Planning Memorandum

Re: **2570 Delaware Avenue – Major Site Plan Review, Conditional Use Permit and Variances**
WSB Project No. 024203-000

SITE ELEMENTS PLAN

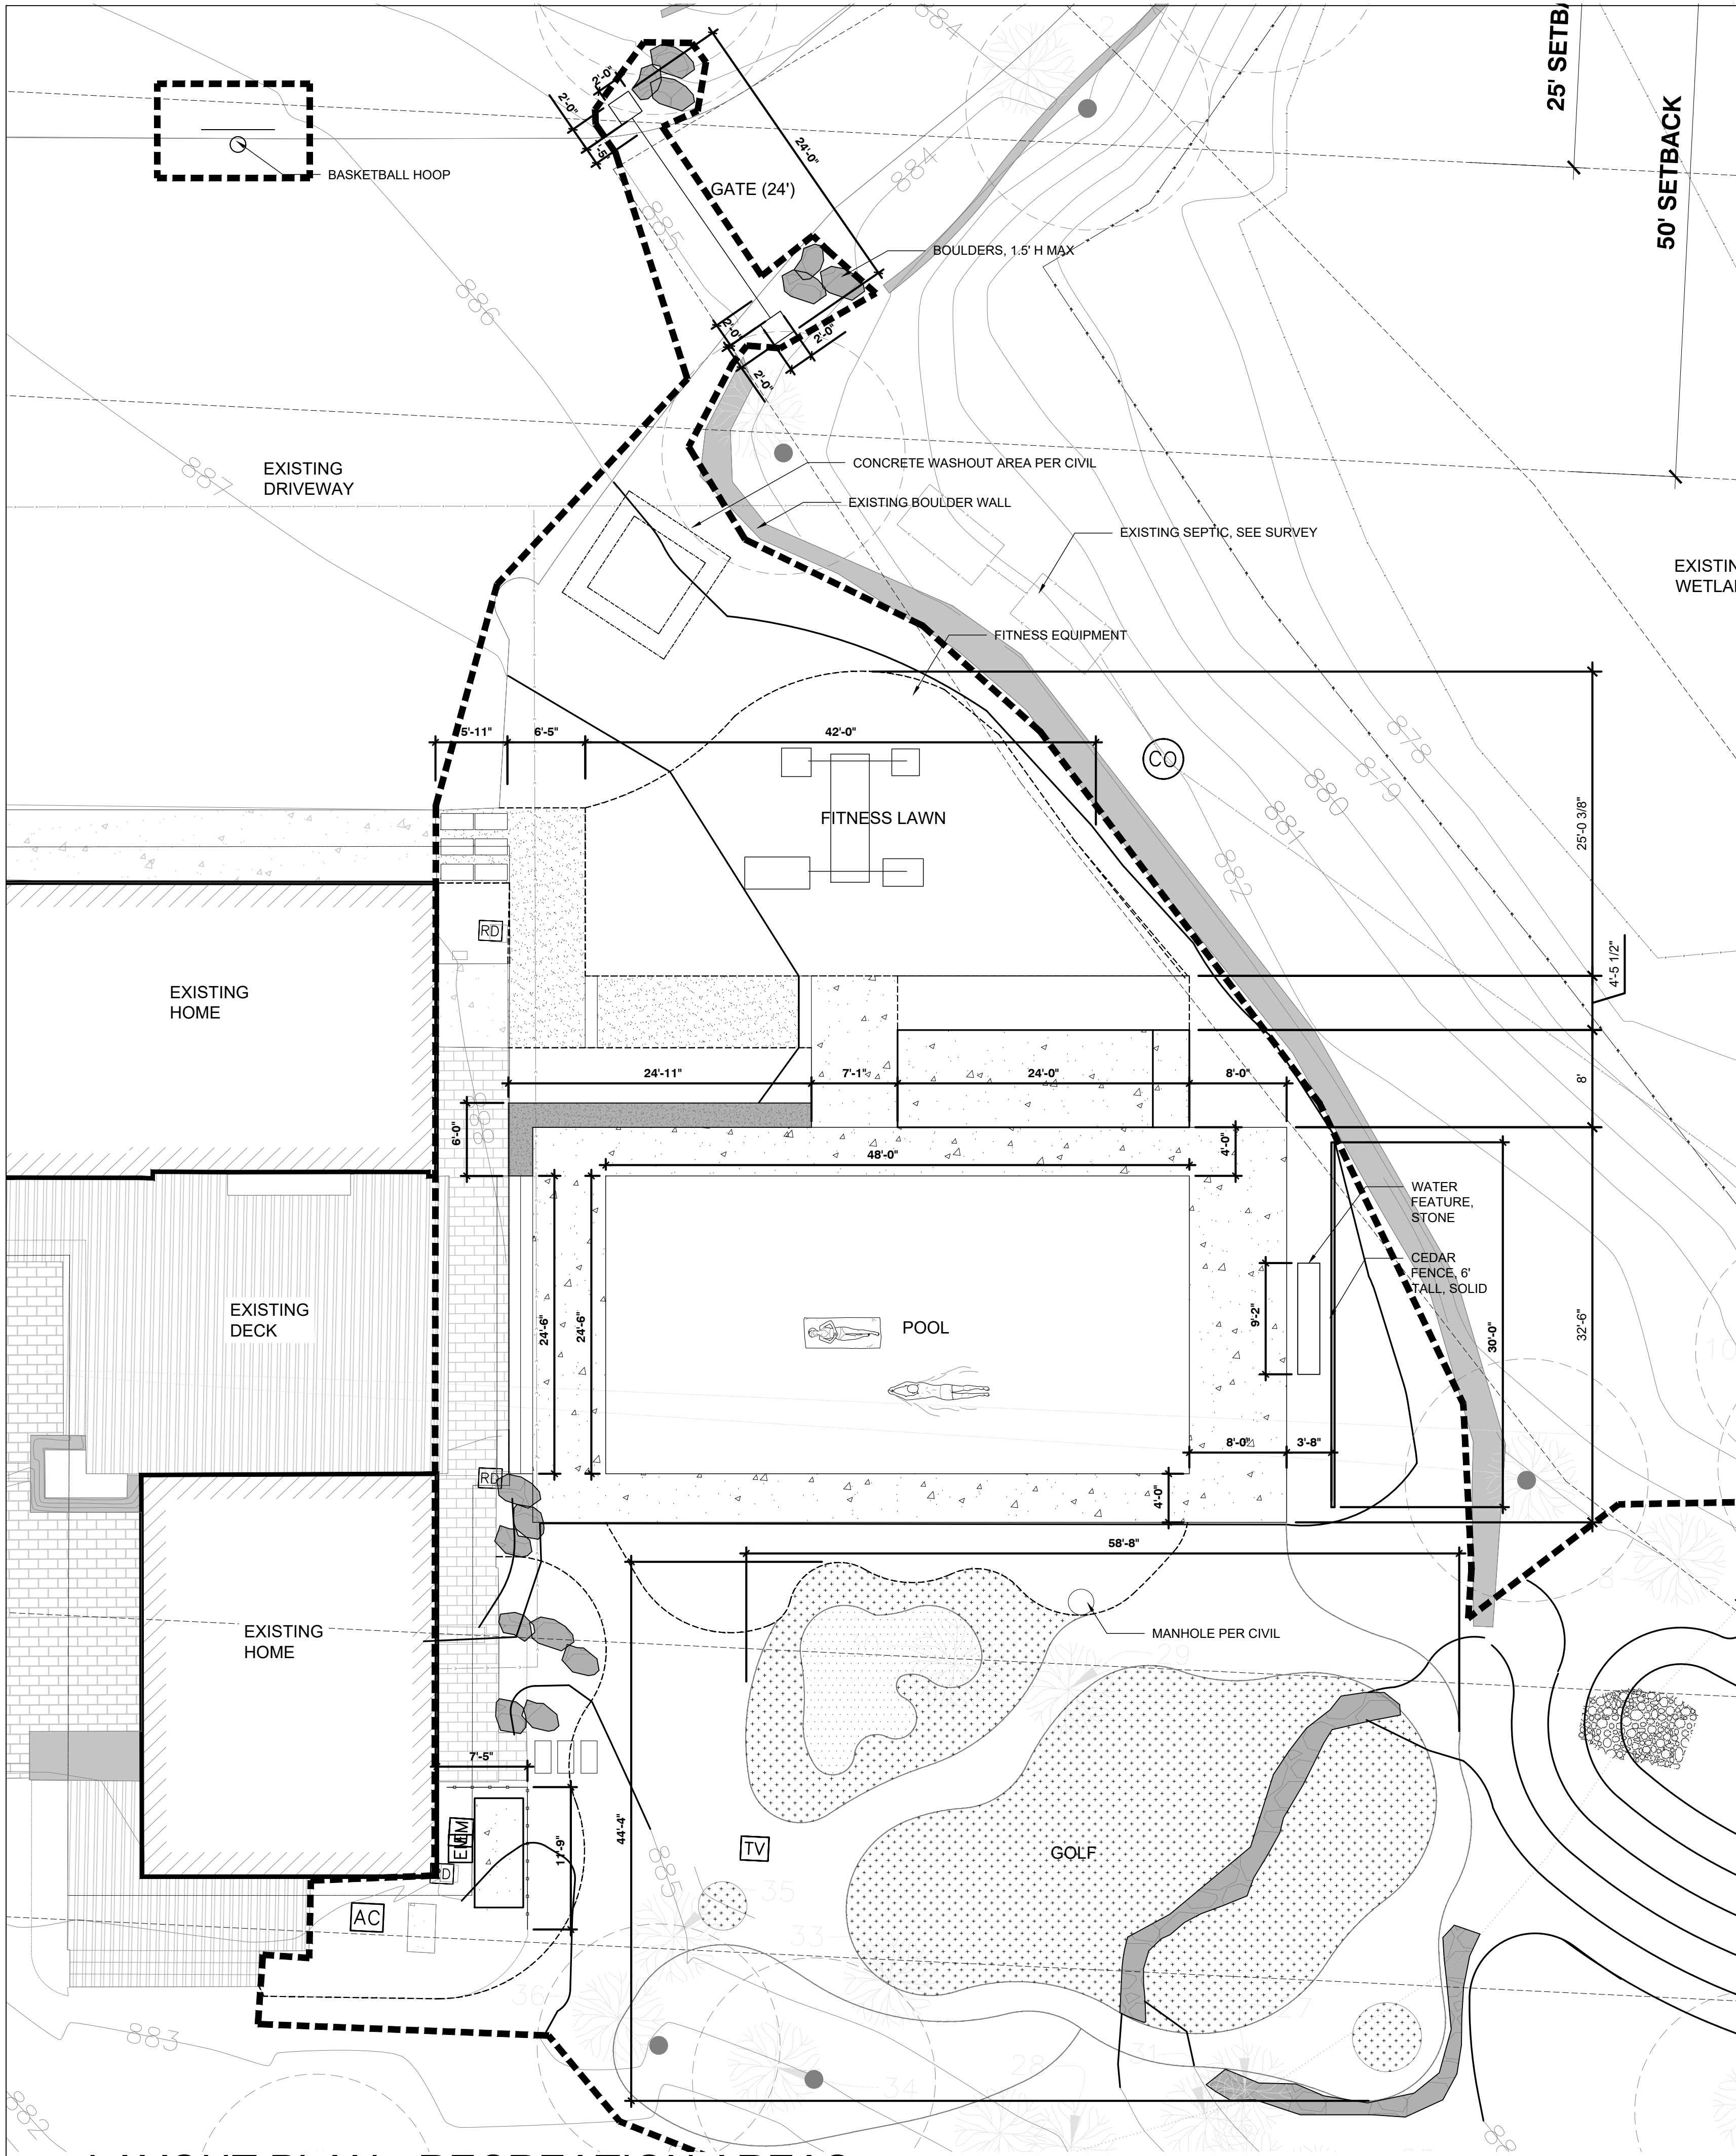
Accessory Uses/Structures: The property owners are proposing to add a pool with a water feature, a 30-foot long, six-foot high wood privacy fence on the east side of the water feature, pergola on the north side of the pool, golf area with putting greens (privacy hedge) on the south side of the pool, and a fitness lawn with a fitness structure pm the northeast corner of the house. These items are all considered accessory uses (with the exception of the fence, which meets ordinance requirements) and are not allowed in the front yard of a property without a conditional use permit. Additionally, the ordinance only allows one accessory building/structure/use per property unless a conditional use permit is issued.

Fencing/Gates: An entrance gate on the northeast side of the home is proposed within the required 50-foot setback. Entrance monuments and gates are required to meet structure setback requirements. The northern monument for the gate is located 22 feet four inches away from the side property line on the north side of the site. The gate/monuments are shown on the attached plans and consist of stone pillars and metal (50% opaqueness). The gate will have an emergency vehicle access siren detector and does include lighting.

The information provided in this staff report and on the proposed plans indicate that all above criteria for granting a setback variance for the entrance gate/ monument are being met with regard to establishing a practical difficulty. Staff recommends approval of the entrance monument/gate variance.

02 LAYOUT PLAN - TREE HOUSE

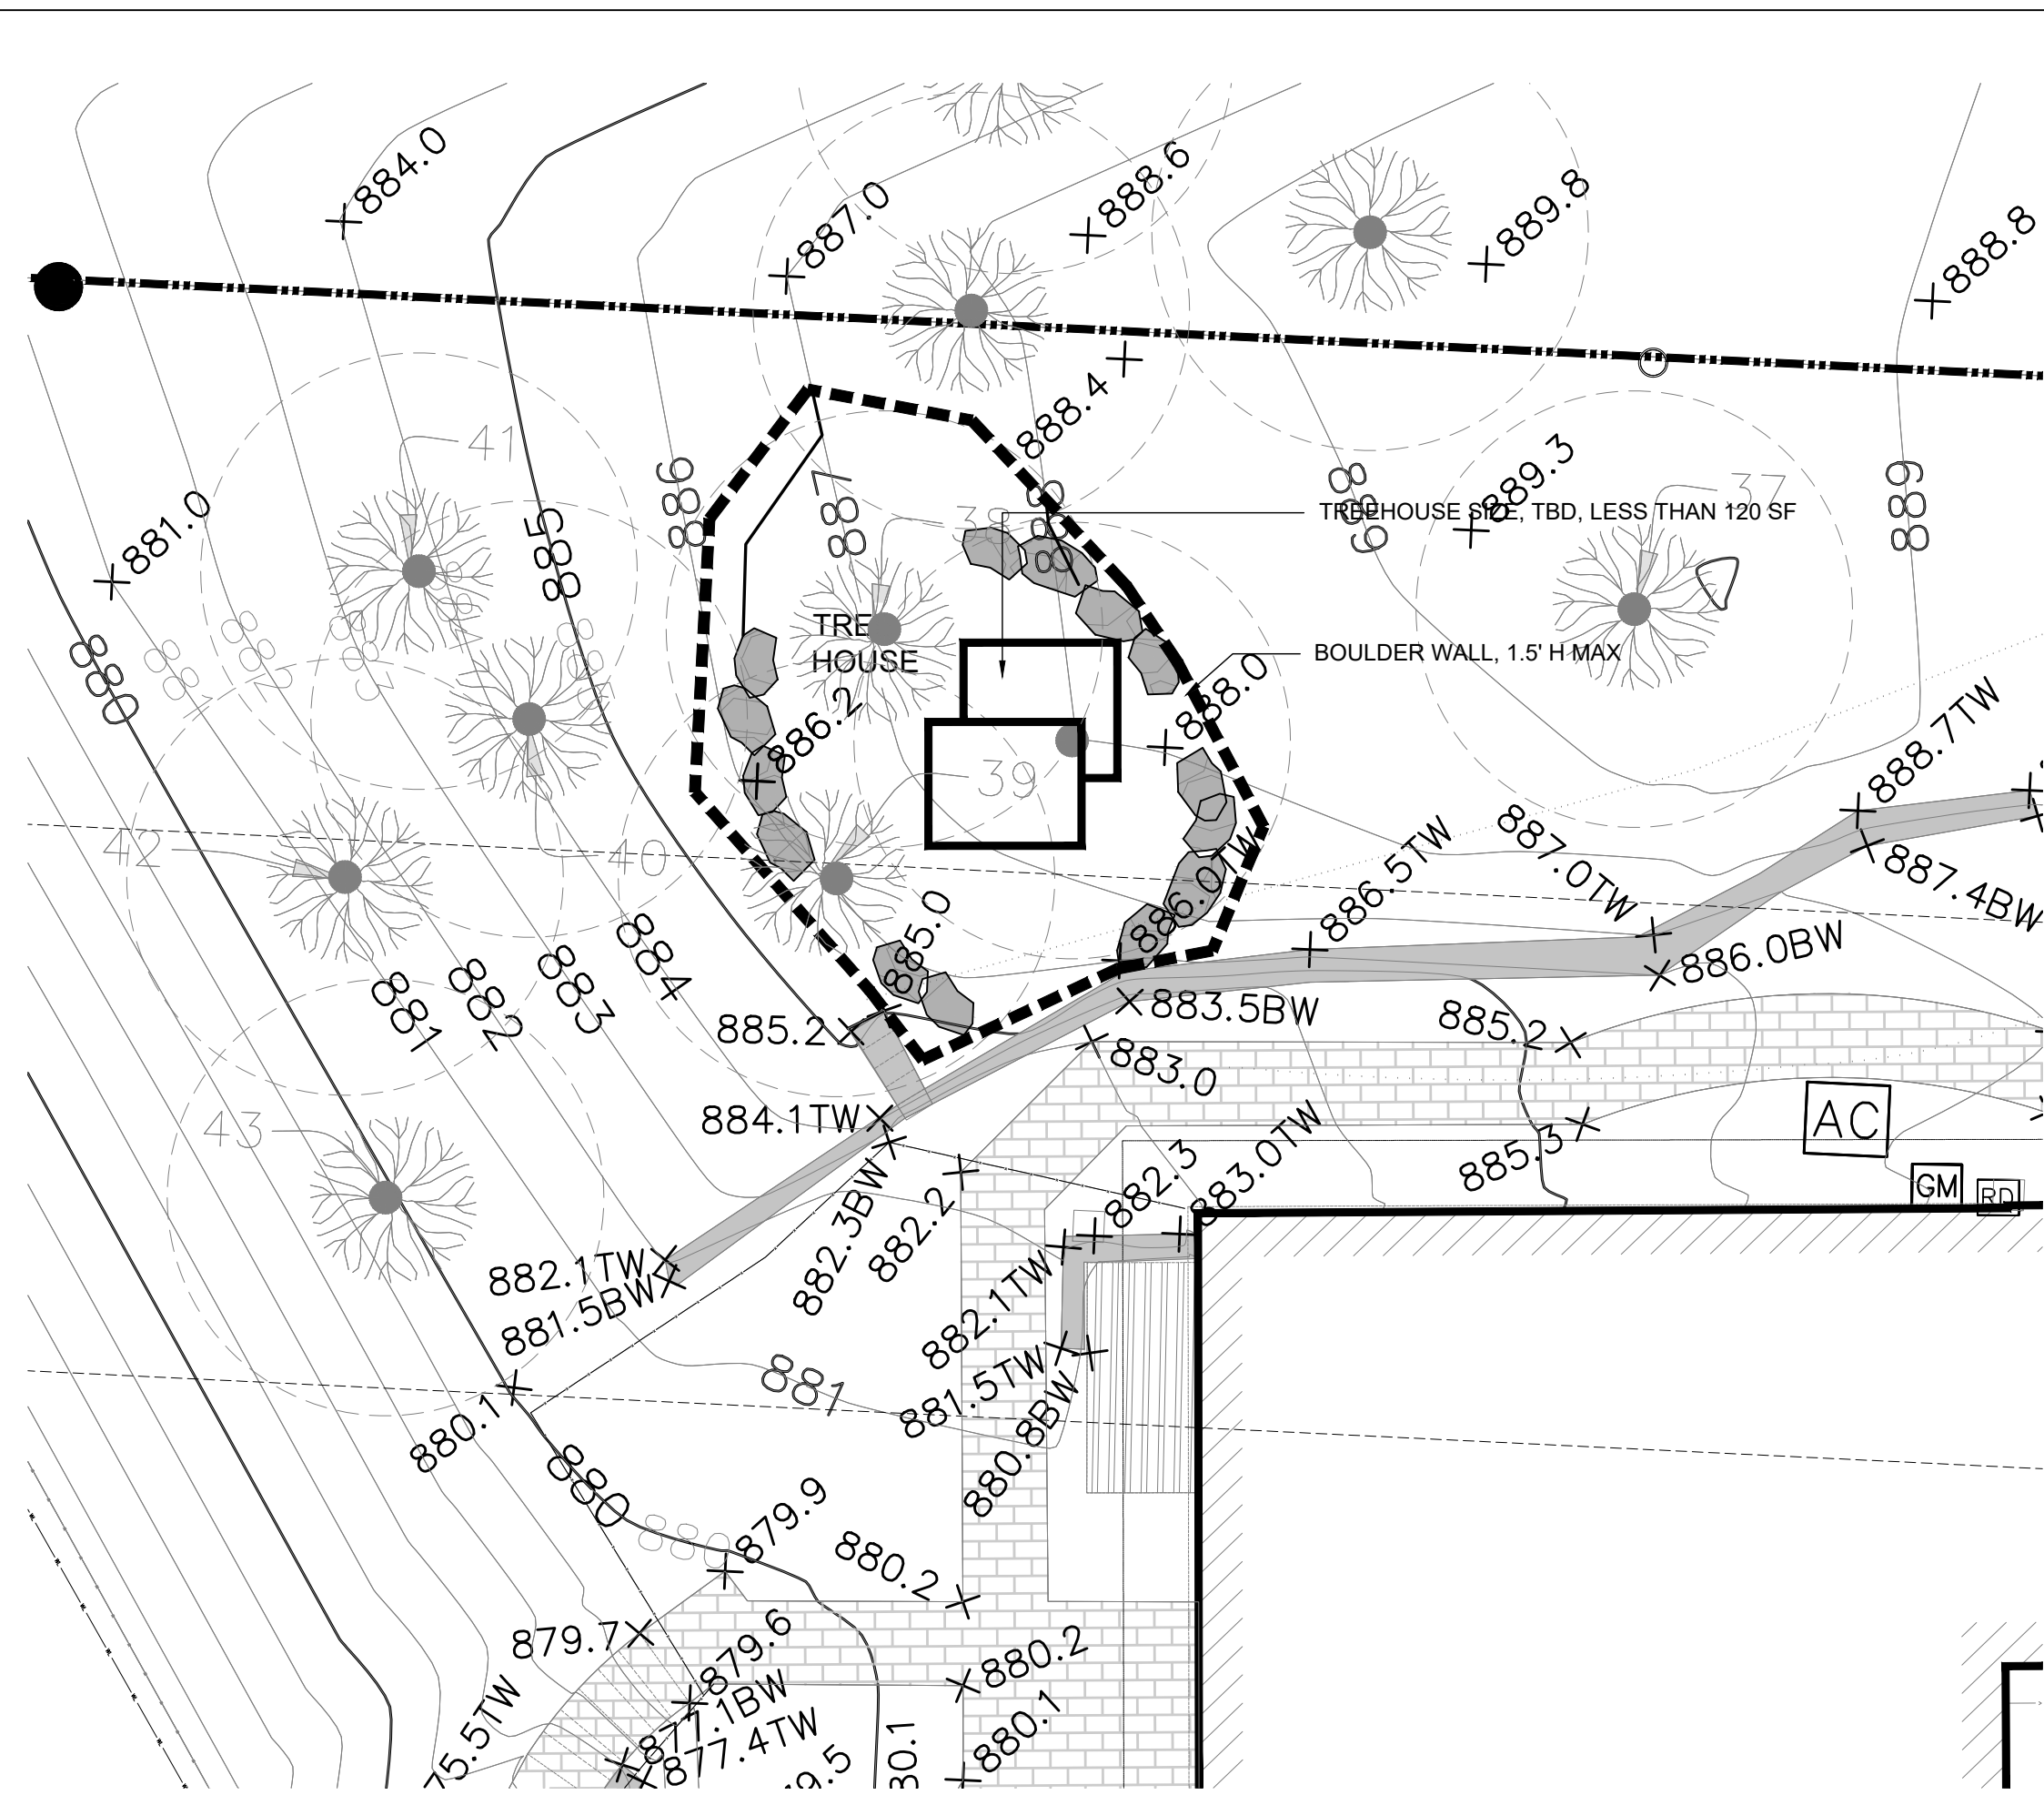
- Variance for the location of a tree house (accessory structure) which is proposed at 14 feet nine inches away from the side property line where a 25-foot setback is required.

The information provided in this staff report and on the proposed plans indicate that all above criteria for granting a setback variance for the treehouse and the setback and length variance for fence are NOT being met with regard to establishing a practical difficulty. Staff recommends denial of the tree house variance and the fence variance.

Upon review of the planning report and application information, the Planning Commission found that the proposed request for a **10.1-foot variance to the 25 foot required side yard setback for the tree house should be denied**. The following findings support the Planning Commission's recommendation for denial of the variance.

1. The applicant will be required to remove the fence prior to administrative site plan approval for the remainder of the proposed work. The applicant will need to supply a site plan indicating such removal. The site plan should also remove the tree house from the plans if the variance for the tree house setback is denied.
